**BEFORE THE NATIONAL GREEN TRIBUNAL,  
PRINCIPAL BENCH, NEW DELHI****OA NO. 127/2024**

**REPLY ON BEHALF OF RESPONDENT NO. 9 / ABCI  
INFRASTRUCTURE PVT. LTD.**

**Subject:** Notice under Water (Prevention and Control of Pollution Act) 1974, Air (Prevention and Control of Pollution) Act, 1981 and non-compliance under C&D Waste Rules, 2016.

Photograph No.1

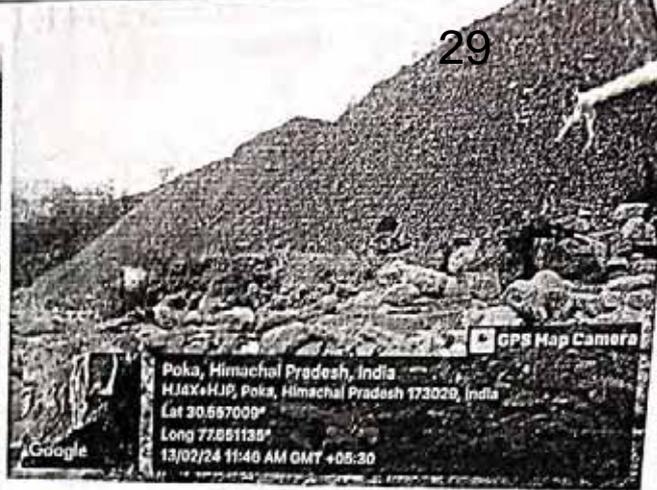
Sr. No	Road Stretch along with chainage	Observations
1	Muck Dumping site at Kando Khad near Sataun Bridge at Chainage Km 16+650	<i>The work has been completed and no further dumping is being carried out this site. It was observed that the retaining structures have been provided toward Kando Nallah to restrict the spillage of muck into nallah. However the retaining structures have been partially damaged and require immediate repair. Photographs are attached herewith.</i>
2	Muck dumping site at Poka road near GSSS Sataun.	<i>Retaining structures provided to retain the muck are not sufficient as same has been provided only on one side of the dumping site while other side of the site is without any retaining structures. Which is resulting into spillage of muck into the Tilgan khad. Photographs are attached herewith.</i>
3	Muck dumping site at at chainage Km 21+300	<i>It was observed that, no retaining structures have been provided towards the downhill side of the site. The muck dumped at this site is directly spilling into valley depression. Necessary retaining structures along with provisions of drainage are required to be provided. Photographs are attached herewith.</i>

Photograph No. 1 and Photograph No. 2 shows status of Site at Kando Khad near Saton Bridge at Chainage Km 16+650

Reference	SI No. 1, Photograph No. 1 & 2
Location	Muck Dumping site at Kando Khad near Sataun Bridge at Chainage Km 16+650
Observation	The work has been completed and no further dumping is being carried out this site. It was observed that the retaining structures have been provided toward Kando Nallah to restrict the spillage of muck into nallah. However, the retaining structures have been partially damaged and require immediate repair. Photographs are attached herewith
Compliance	Suitable protection work i.e. gabion structure was provided to retain the filled material at muck dumping site located at Ch. 16+650, however the extreme weather conditions damaged the completed works. This dumping site has already been closed and no further dumping is being carried out. Notwithstanding, in compliance of the observation made, retaining structure has been restored. please refer photographs furnished below.

**Non designated muck dumping at Sataun after site No.4**

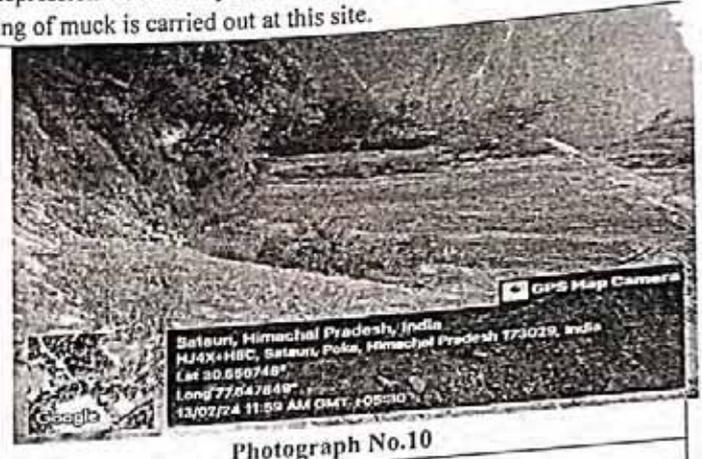
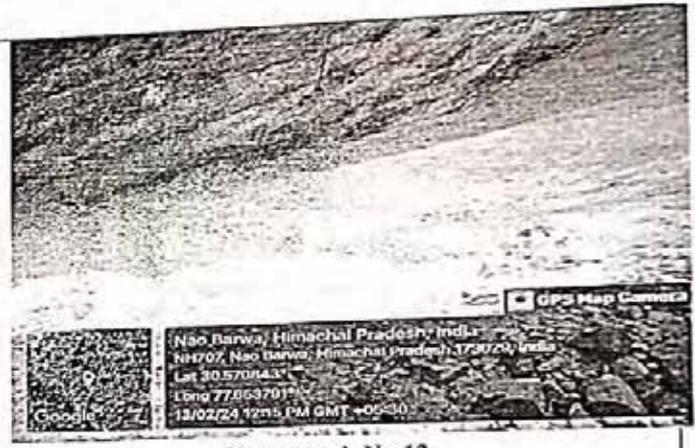
It was observed that the muck is directly disposed into the valley depression without any retaining structures. Immediate preventive measure are required to be taken and further ensure that, no dumping of muck is carried out at this site.

Photograph No. 9 & Photograph No. 10 shows status of muck dumping at Sataun after site No.4 at Sataun

It is most humbly submitted that dumping of muck has not been done at any non-designated site. We have obtained permissions/consents from the respective landowners/department for disposal of the muck and provided the required retaining structures however the extremely adverse weather conditions i.e. unprecedented rains, cloud burst and landslides in the recent past has damaged the completed works. Copies of the permissions/consents from the respective landowners/department for disposal of the muck are enclosed herewith.

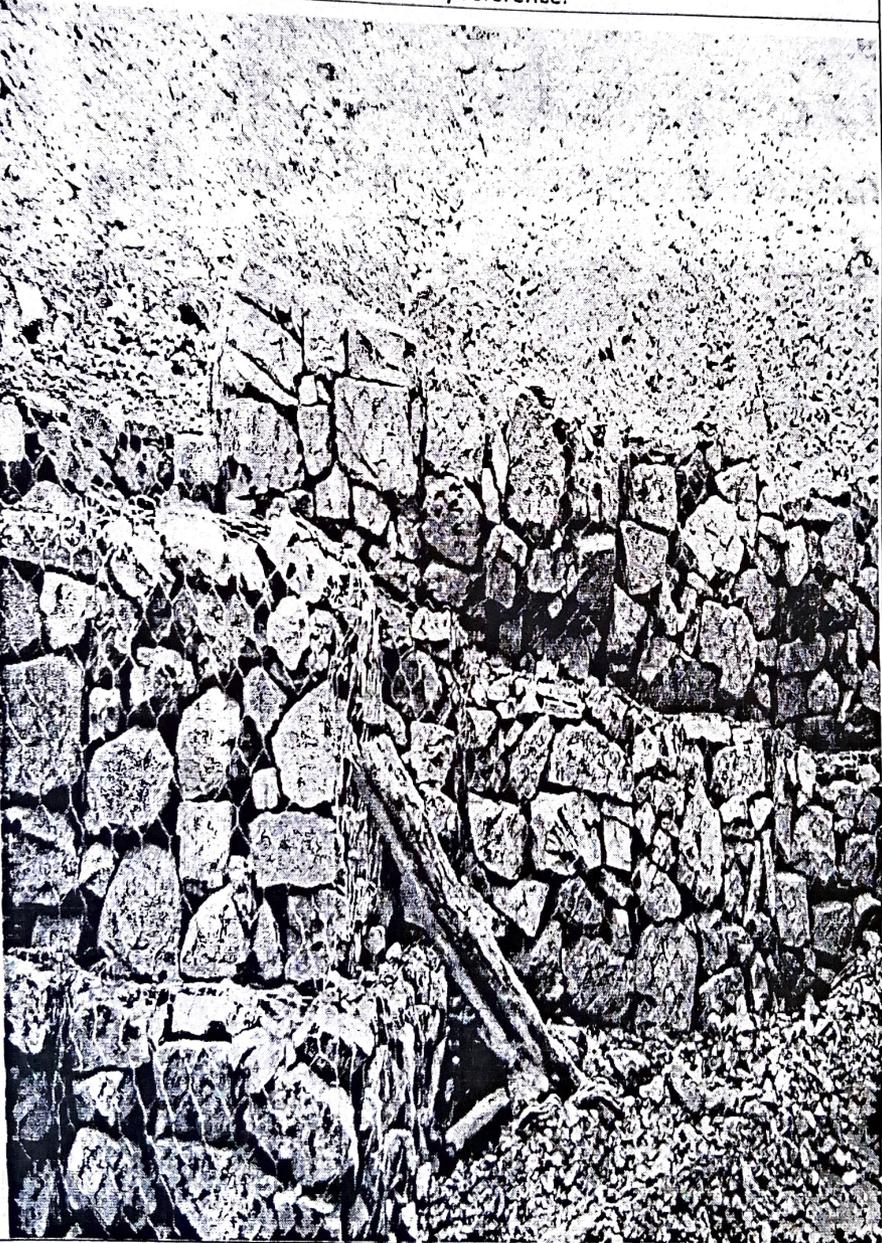
Reference	SI No. 2, Photograph No. 3 & 4
Location	Muck Dumping site at Poka road near GSSS Sataun
Observation	<i>Retaining structures provided to retain the muck are not sufficient as same has been provided only on one side of the dumping site while other side of the site is without any retaining structures. Which is resulting into spillage of muck into the Tilgan khad. Photographs are attached herewith.</i>
Compliance	The dumping site located at Km. 20+200 (Saton Poka road) is being used for disposal of muck. The suitable protection works i.e. Gabion structure is provided to retain the filled material on the other side is provided. The photographs are furnished below for your ready reference.
	 <p>Latitude: 30.517267 Longitude: 77.650811 Elevation: 566.79914 m Accuracy: 0.8 m Time: 01/03/2024 15:29 Note: gabion work at 0/2000</p>
	 <p>Latitude: 30.517217 Longitude: 77.650811 Elevation: 562.78201 m Accuracy: 0.8 m Time: 01/03/2024 15:31 Note: gabion work at 0/2000</p>

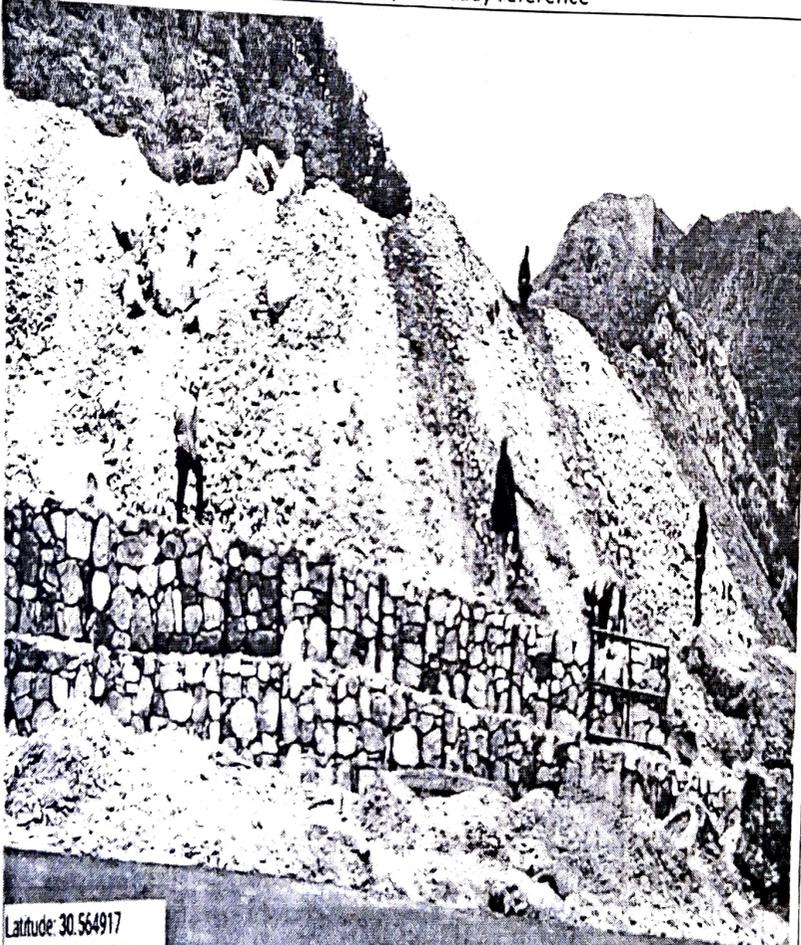
Reference	SI No. 4, Photograph No. 7 & 8
Location	Muck dumping site near Hewna Temple at chainage 24+400
Observation	<i>The provided retaining structure were damaged in past due to flash flood in the district. The company is required to provided/repair necessary retaining structures in along the downside of hill so that, muck can be retained and spillage of same can be avoided. Photographs are attached herewith.</i>
Compliance	The dumping site located at Km 24+400 near Hewan Temple is being used for protection of temple and not for muck disposal. We have developed the front yard of the temple and provided toe wall. Photographs are enclosed herewith for your ready reference.
	 <p>Latitude: 30.579108 Longitude: 77.657492 Elevation: 987.65±10 m Accuracy: 7.2 m Time: 01-03-2024 16:43 Note: Retaining wall at kms 24.300</p>
	 <p>Latitude: 30.579001 Longitude: 77.65748 Elevation: 982.76±7 m Accuracy: 7.2 m Time: 01-03-2024 16:44 Note: Retaining wall at kms 24.300</p>
